Access Compliance Report

Public Rights-of-Way

(Pedestrian Signals)

Intersection ID: N/A	Main Street:	Cross Street: N/A	Location: N/A
ADA ID: A8AC484E5125	Signal Type: Two Push Buttons-Non APS	Overall Compliance: No	Severity Score: BTN 1:N/A BTN 2: N/A No BTN: N/A
Codes/Mitigation Info/Possible Solution		Field Measurements/Component Compliance

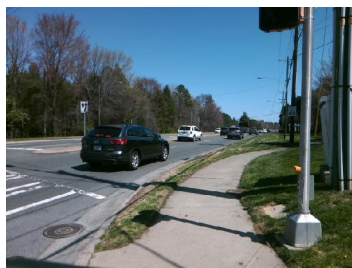
N/A	B 1 FWD Approach Width (in)	N/A	N/A	B 2 FWD Approach Width (in)	N/A
N/A	B 1 FWD Approach Obstruction?	Yes	N/A	B 2 FWD Approach Obstruction?	Yes
N/A	B 1 FWD Approach Obstruction Dist (in)	2.0	N/A	B 2 FWD Approach ObstructionDist (in)	3.0
N/A	B 1 PARA Approach?	Yes	N/A	B 2 PARA Approach?	Yes
N/A	B 1 PARA Approach Constrained?	Yes	N/A	B 2 PARA Approach Constrained?	Yes
Yes	B 1 PARA Approach Reach (in)	8.0	Yes	B 2 PARA Approach Reach (in)	8.0
No	B 1 PARA Approach Width (in)	48.0	No	B 2 PARA Approach Width (in)	48.0
N/A	B 1 PARA Approach Obstruction?	Yes	N/A	B 2 PARA Approach Obstruction?	Yes
N/A	B 1 PARA Approach Obstruction Dist (in)	3.0	N/A	B 2 PARA Approach ObstructionDist (in)	4.0
No	B 1 Clear Floor Space Slope (%)	7.2	No	B 2 Clear Floor Space Slope (%)	7.2
No	B 1 Clear Floor Space XSlope (%)	3.7	No	B 2 Clear Floor Space XSlope (%)	2.6
N/A	B 1 PAR Slope (%)	N/A	N/A	B 2 PAR Slope (%)	N/A
Yes	B 1 Height (in)	34.0	Yes	B 2 Height (in)	34.0

N/A	B 1 Clear Xing Direction?	Yes	N/A	B 2 Clear Xing Direction?	Yes
	B 1 Crossing Direction	To NW		B 2 Crossing Direction	To SW
Yes	B 1 DistanceTo XWalk (in)	12.0	Yes	B 2 DistanceTo XWalk (in)	0.0
No	B 1 DistanceTo Curb (in)	91.0	No	B 2 DistanceTo Curb (in)	91.0
Yes	B 1 Diameter (in)	2.0	Yes	B 2 Diameter (in)	2.0

Possible Solutions: Replace Signal Push Button With APS Button on New Post. Remove & Replace Sign.
